1.1 Company		STMicroelectronics International N.V
1.2 PCN No.		ADG/21/12697
1.3 Title of PCN		DPAK 3 mils Al Gate wire, Dual Gauge Matrix, Large Die Pad capacity expansion - TFME (China) - INDUSTRIAL
1.4 Product Category		Power MOSFET HV
1.5 Issue date		2021-03-30

Automotive Discrete Group (ADG)  
Power Transistor MACRO-Division  
HV Business Unit  
**Process Change Notification**

**DPAK 3 mils Al Gate wire, Dual Gauge Matrix, Large Die Pad capacity expansion - TFME (China)**

## DPAK (TO-252) type A2 package outline

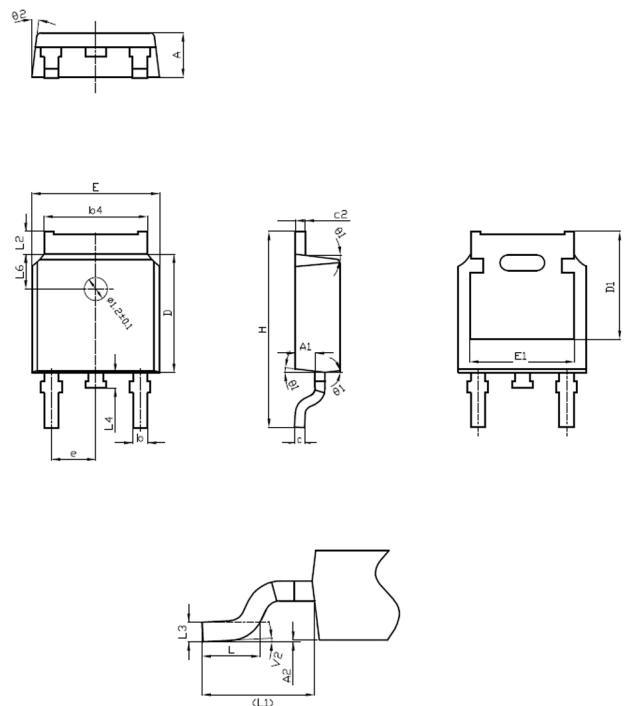
# DPAK Large Die Pad STS

# DPAK Large Die Pad TFME
